Laney

Service Diagrams

DRAWN	DEH
DATE	17/10/96
TITLE	120W / 150W OUTPUT BOARD
DRW. NO.	9115_2

DRAWN	DEH
DATE	17/10/96
TITLE	100/120/150 OUTPUT
DRW. NO.	9115

DRAWN	DEH
DATE	17/10/96
TITLE	120W/150W OUTPUT PCB
DRW. NO.	9115_3

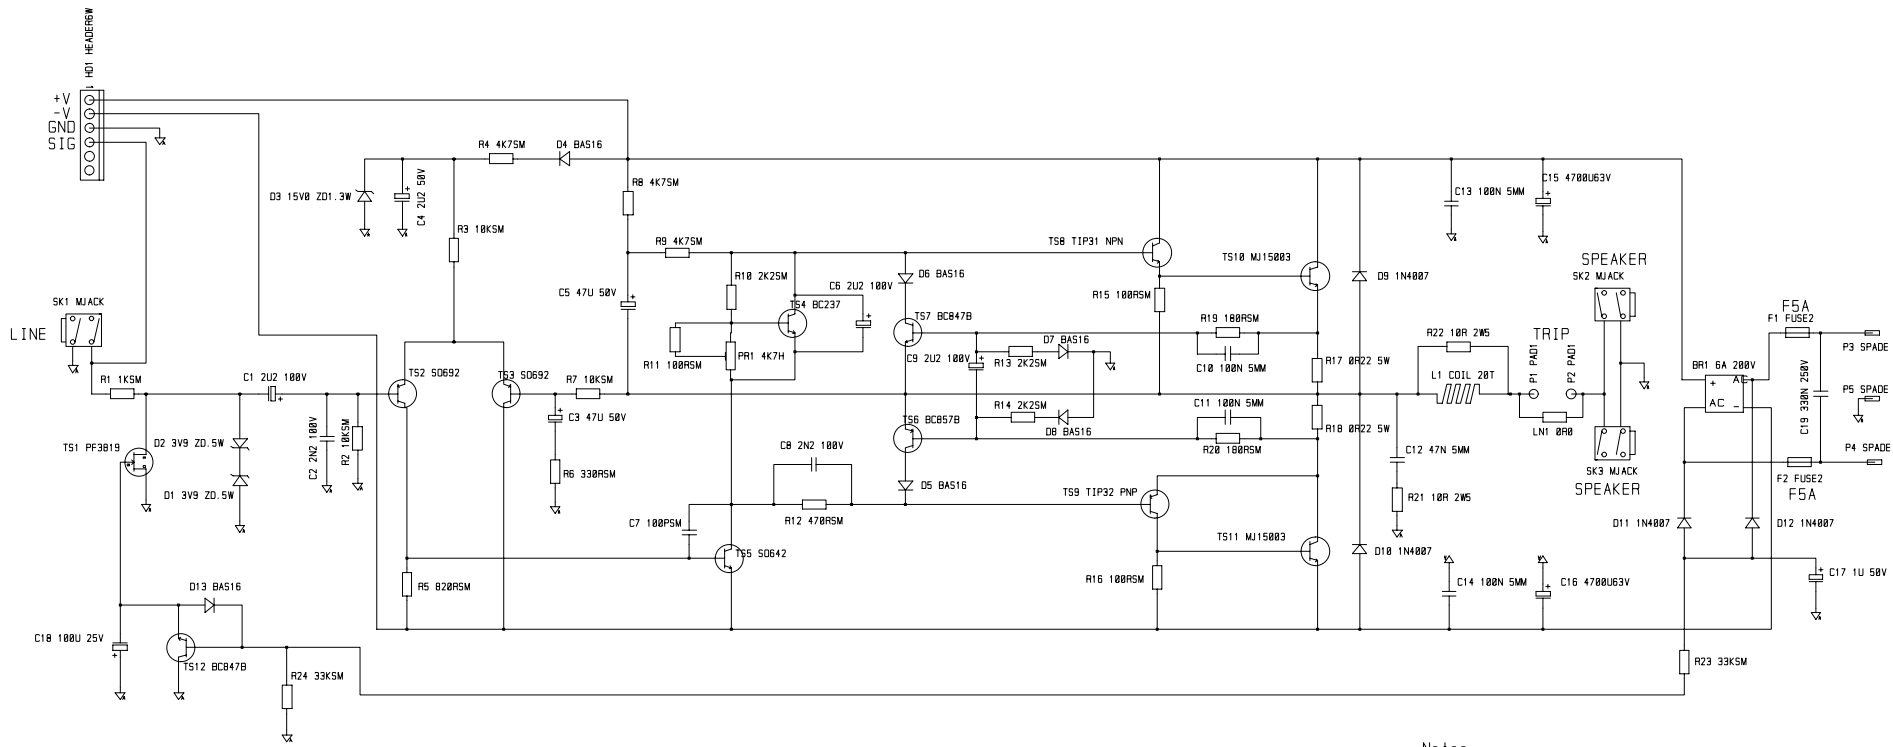
ISSUE	3	3	3		
TYPE	LAYOUT CHANGE 22/01/97	R8 & R9 CHANGED FROM 2K2 TO 4K7 - 7/4/97 SEE CHANGE NOTE No.96	F1 and F2 Changed See Change Note 197

Notes
 For 150W Models F1 + F2 should be F4A
 For 100 - 120W Models F1 and F2 should be F3.15A

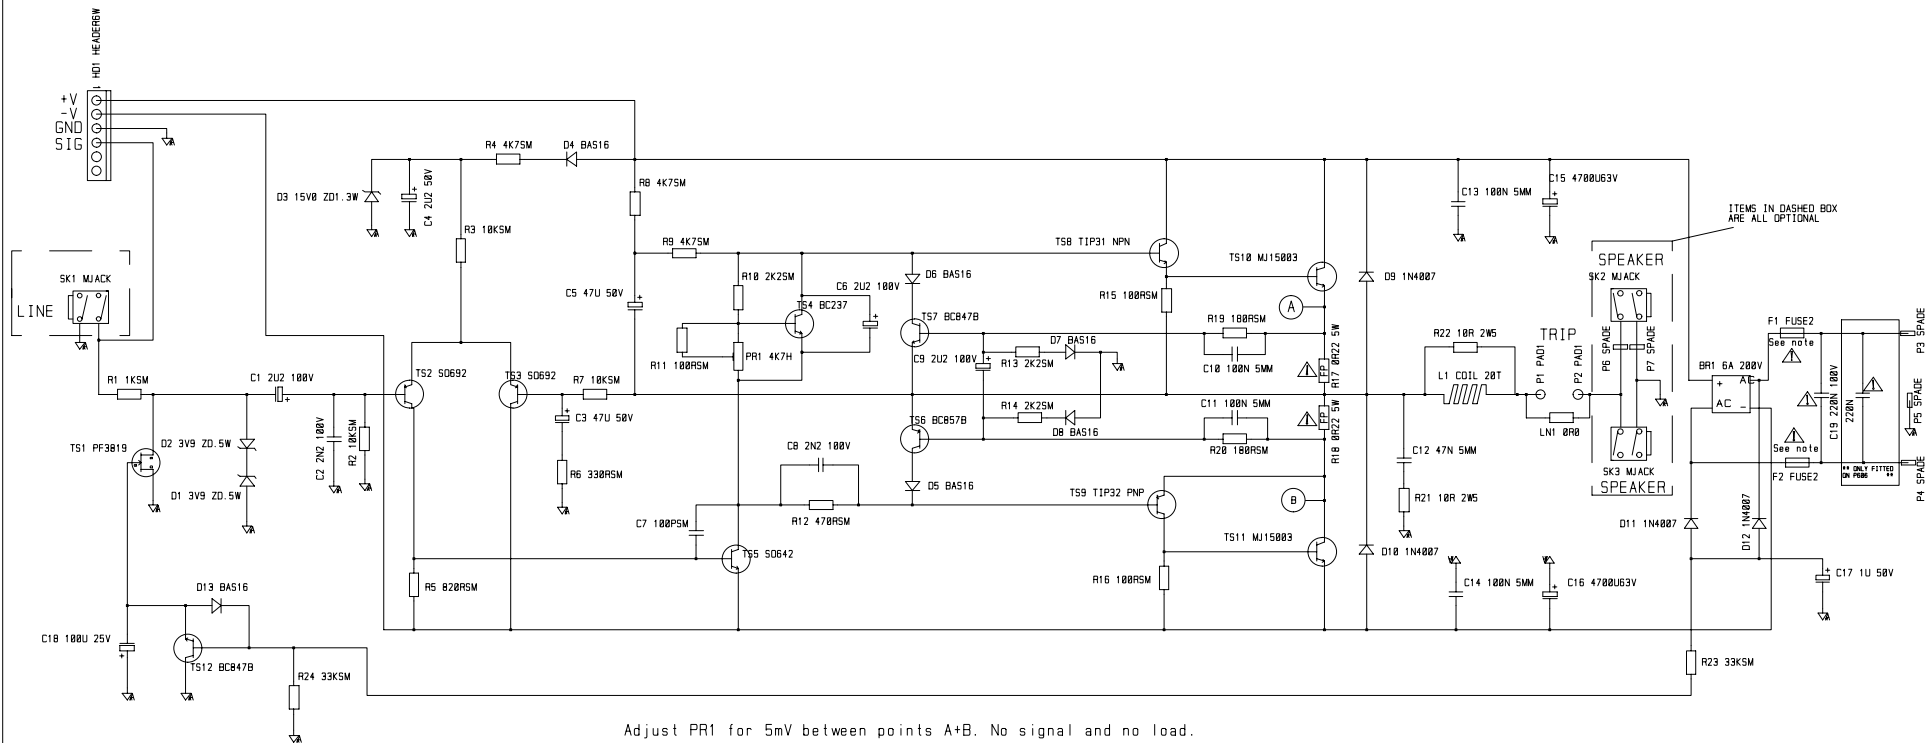
ISSUE	3	3	4	4	
TYPE	LAYOUT CHANGE 22/01/97	R8 & R9 CHANGED FROM 2K2 TO 4K7 - 7/4/97 SEE CHANGE NOTE No.96	SPEAKER SPADE TERMINALS ADDED 08/04/98	1 off 220nF 100V ADDED ACROSS C19 P606S ONLY

NOTE: FUSE VALUES FOR F1 & F2.
 100-120 WATT = F3.15A
 150 WATT = F4A
